CITY AND COUNTY OF SAN FRANCISCO
Port of San Francisco

Contract No. 2852
Amador Street Infrastructure Improvements

ADDENDUM No. 03
Issued: August 19, 2024

AMADOR STREET
INFRASTRUCTURE IMPROVEMENTS
AMADOR STREET
PAVING PLAN
STA 12+00 TO 17+50

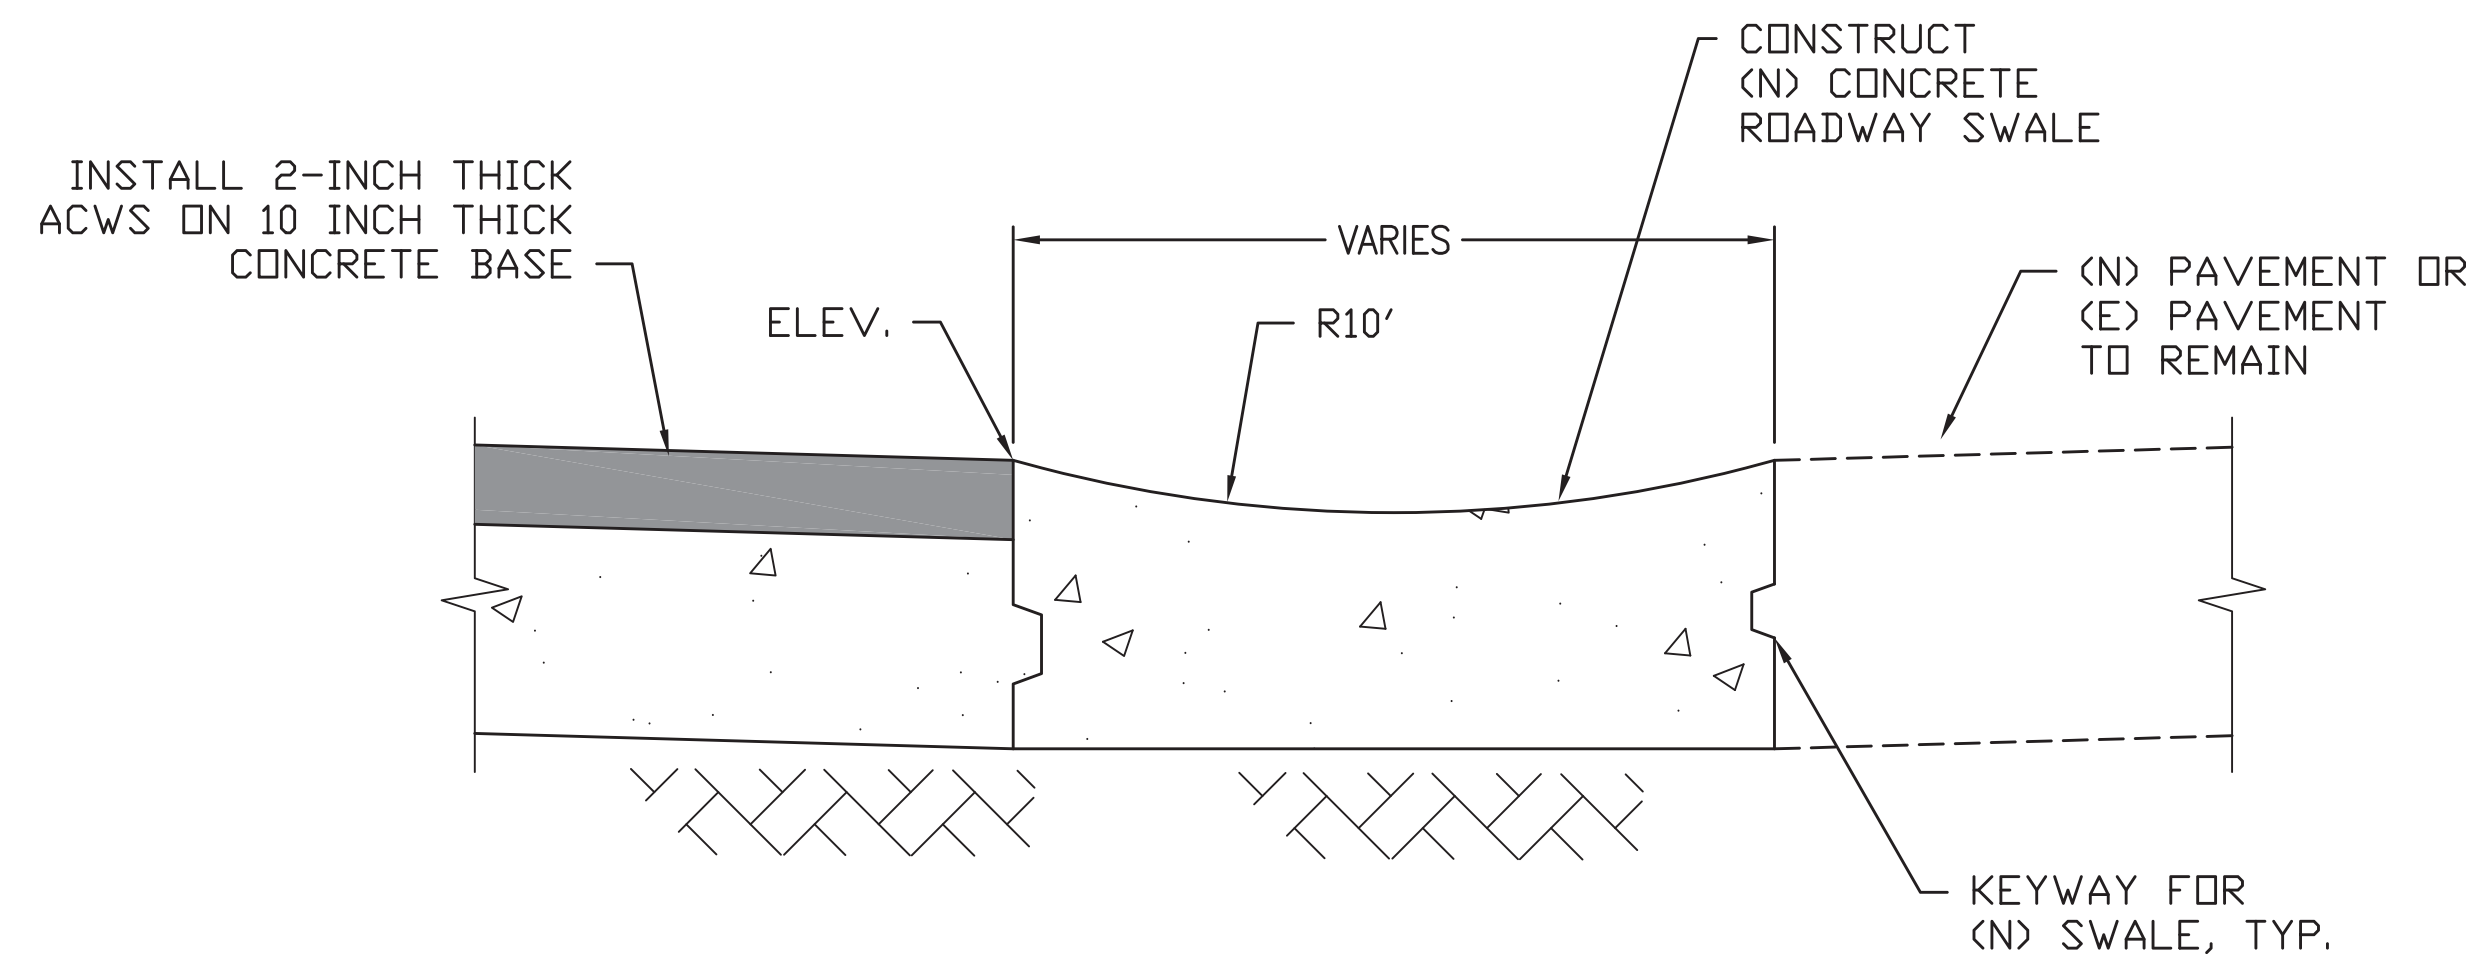
- 1) **Sheets C-3 & C-6** – Modifications to driveway designs and details.
- 2) **Sheets L-3** – Updated specification references related to imported topsoil.
- 3) **Sheets H-2, H-4, H-5, & H-10** – DELETED work related to installation of high flow trash
- 4) **Sheets E-3** – Updated antenna material to aluminum.
- 5) **Sheets E-5, EI-01, & EI-02** – Updated service pedestal mounting.

ENLARGED PLAN "E"
SCALE: 1"=5'

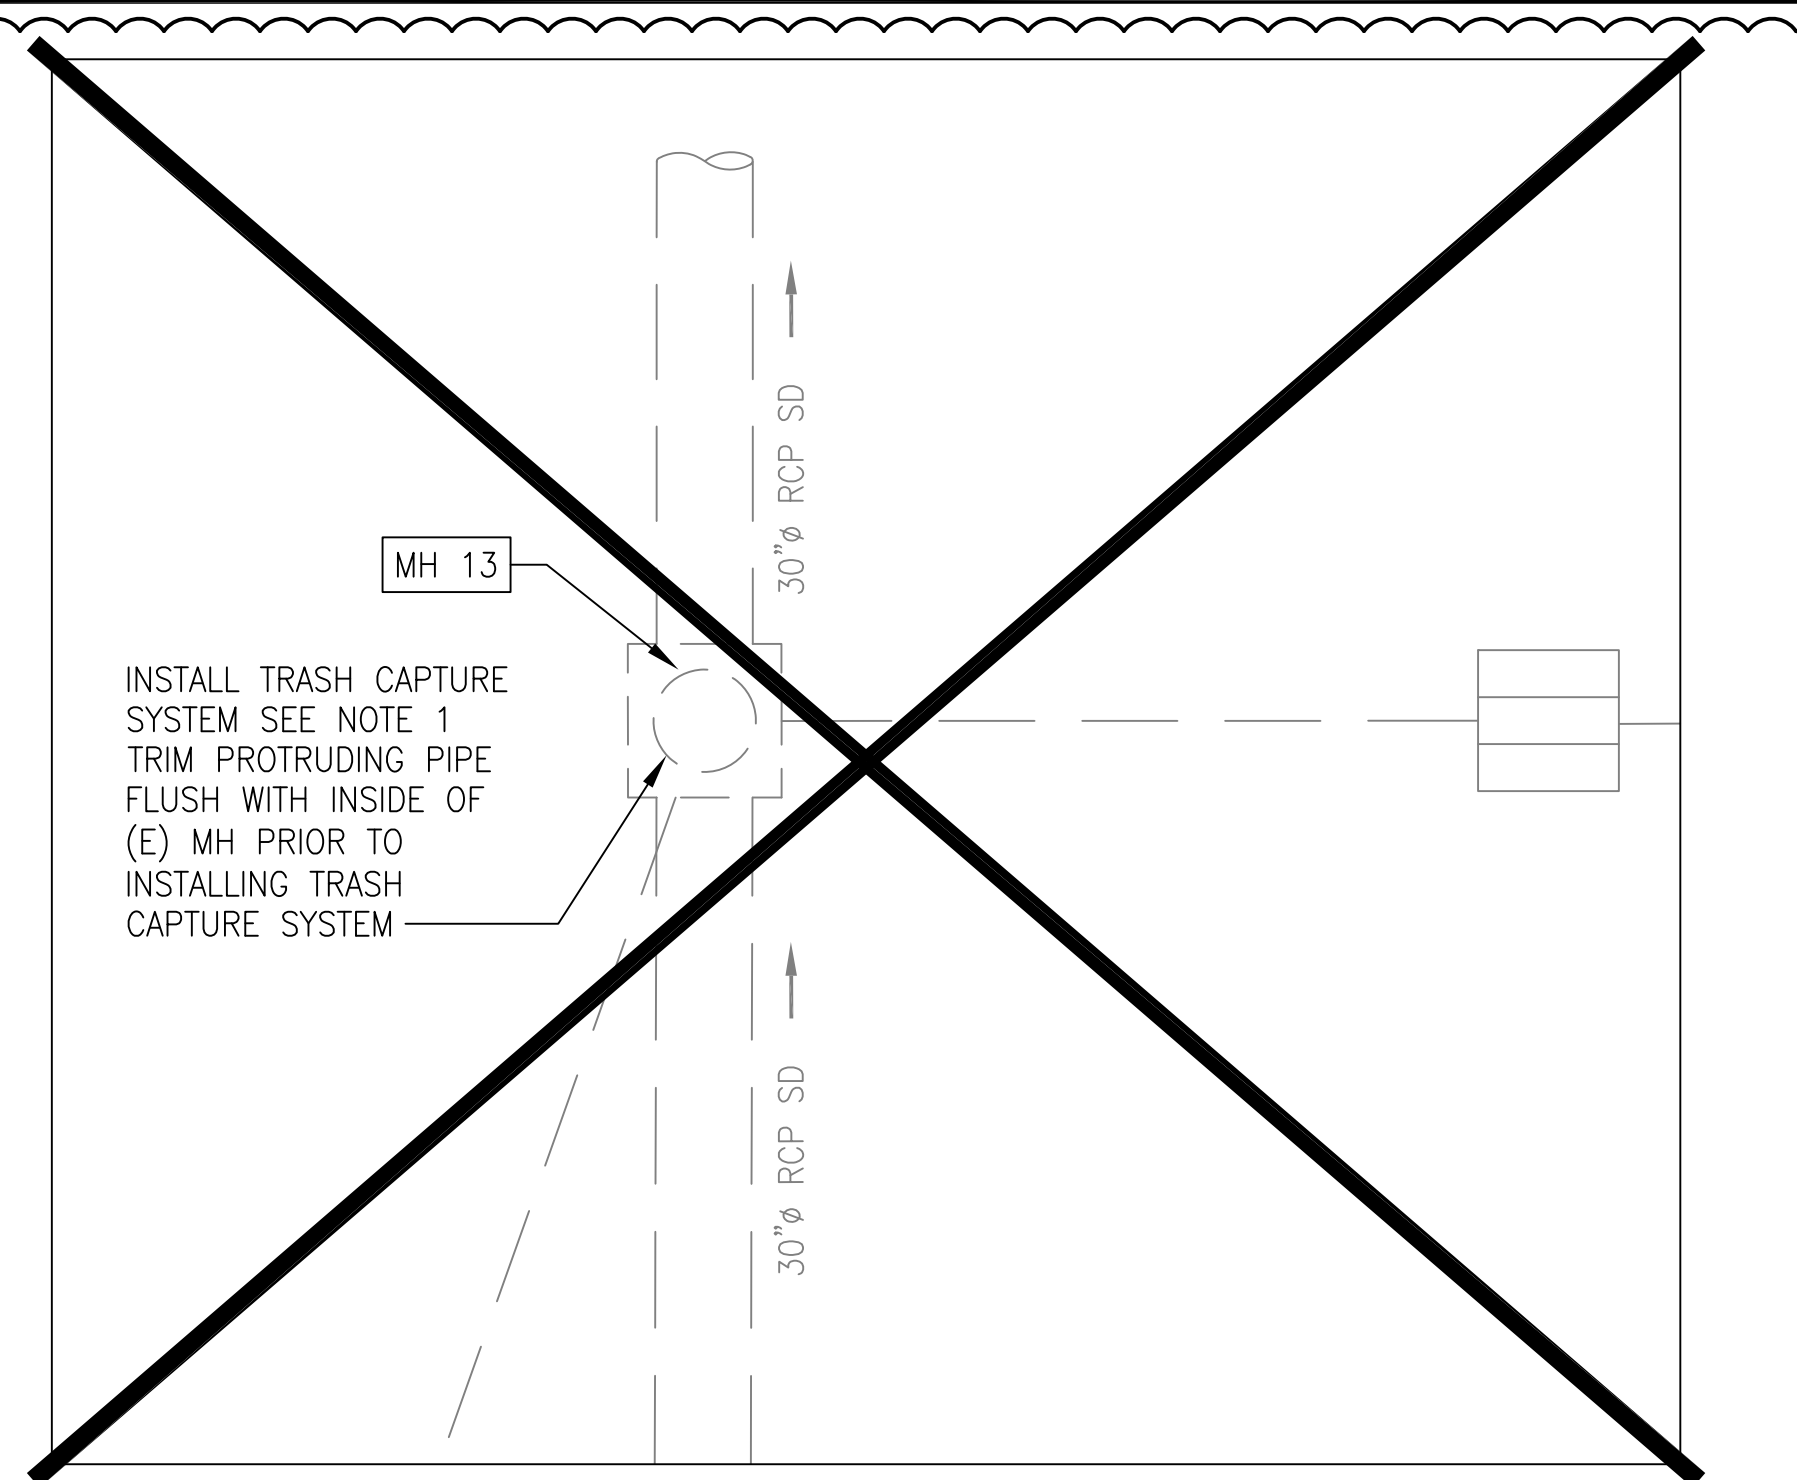
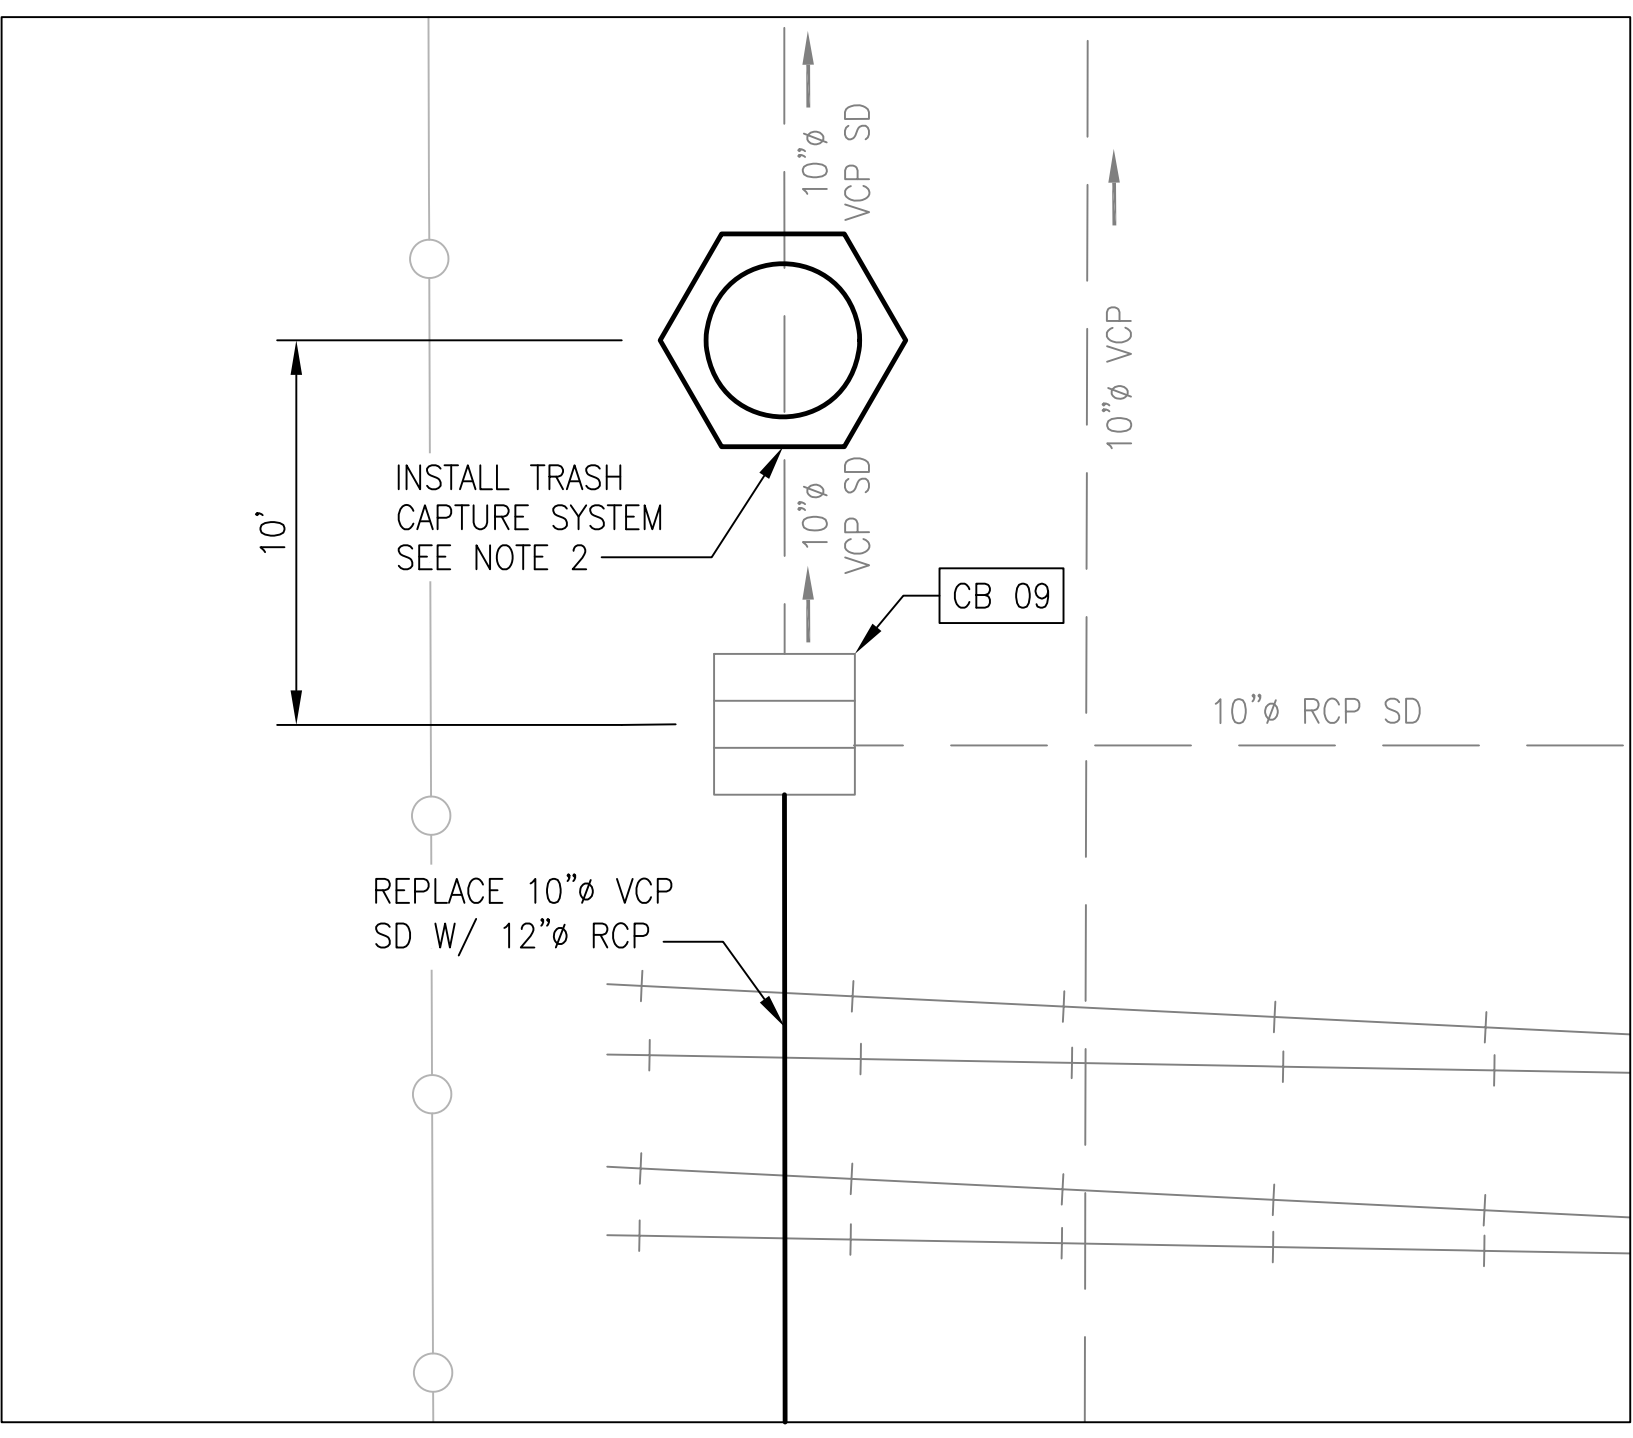
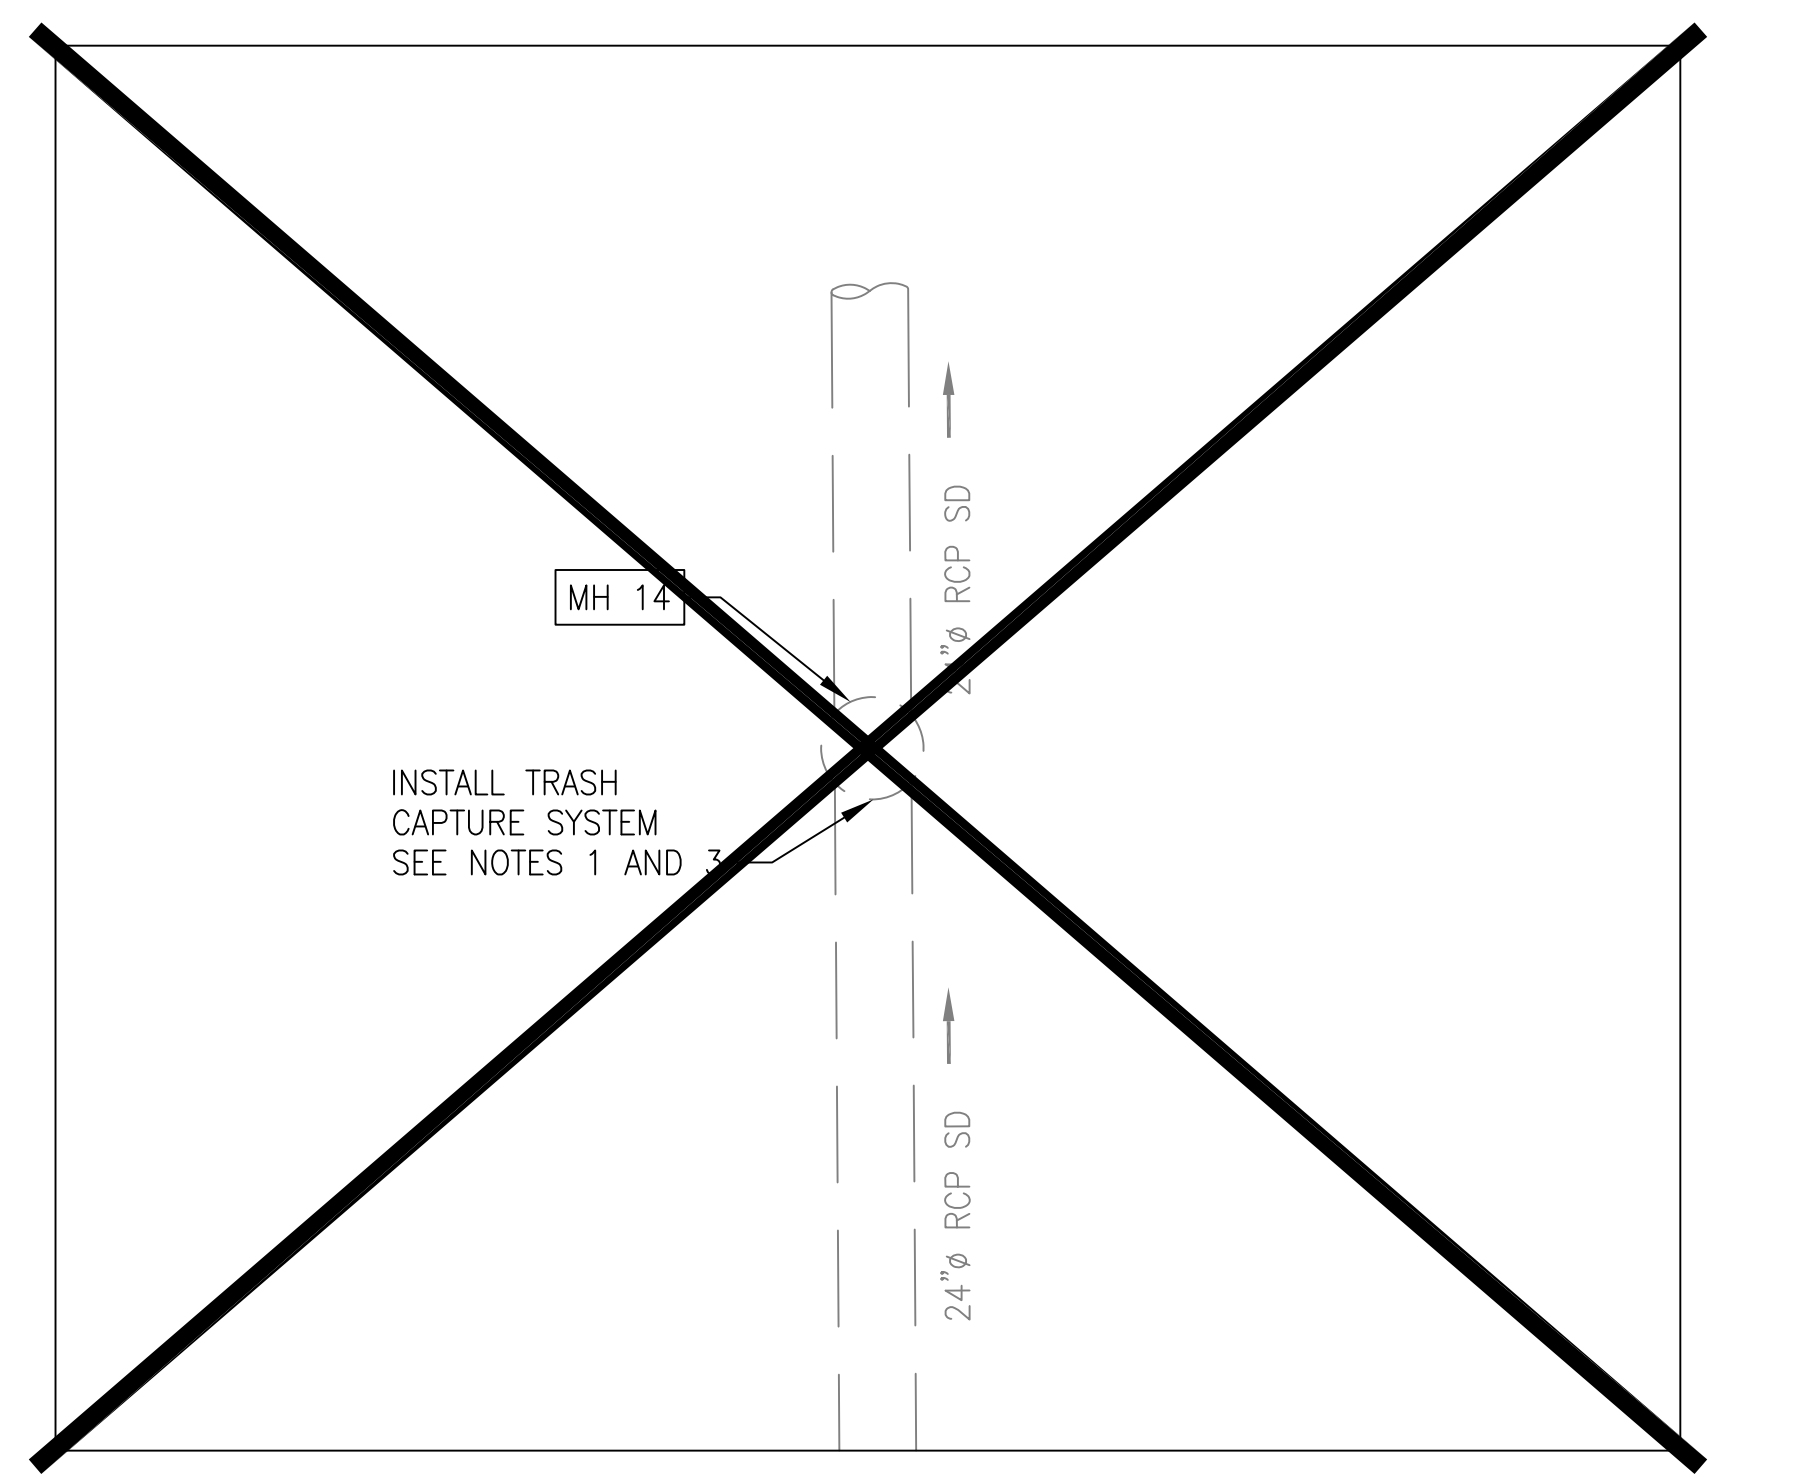
- FURNISH AND INSTALL HIGH FLOW DEVICE, CROSSLINKED HIGH DENSITY POLYETHYLENE "DOWNSTREAM DEFENDER" BY HYDRO INTERNATIONAL INSIDE (E) MH. SEE SPEC SECTION 33 33 00 FOR ADDITIONAL REQUIREMENTS.
- FURNISH AND INSTALL HIGH FLOW DEVICE "JDS72-3636 JENSEN DEFLECTIVE SEPARATOR" OR APPROVED EQUAL BY THE CITY REPRESENTATIVE. SEE SPEC SECTION 33 33 00 FOR ADDITIONAL REQUIREMENTS.
- EXISTING MH IS INSIDE CEMEX LEASEHOLD. CONTRACTOR SHALL COORDINATE WITH THE CITY REPRESENTATIVE FOR ACCESS TO PERFORM THE WORK. EXISTING MANHOLE HAS EXISTING GRATE COVER OVER SOLID MANHOLE COVER.
- TRASH CAPTURE DEVICES SHALL BE RATED FOR THE FOLLOWING FLOW RATES (MIN):
 A) PLAN "C": 5.2 (CFS)
 B) PLAN "D": 1.4 (CFS)
 C) PLAN "E": 12.1 (CFS)
 D) PLAN "F": 3.3 (CFS)

- M. High flow removable trash collection device with new concrete manhole "JDS72-3636 Jensen Deflective Separator", conforming to the requirements in the Contract Plans, or approved equivalent.
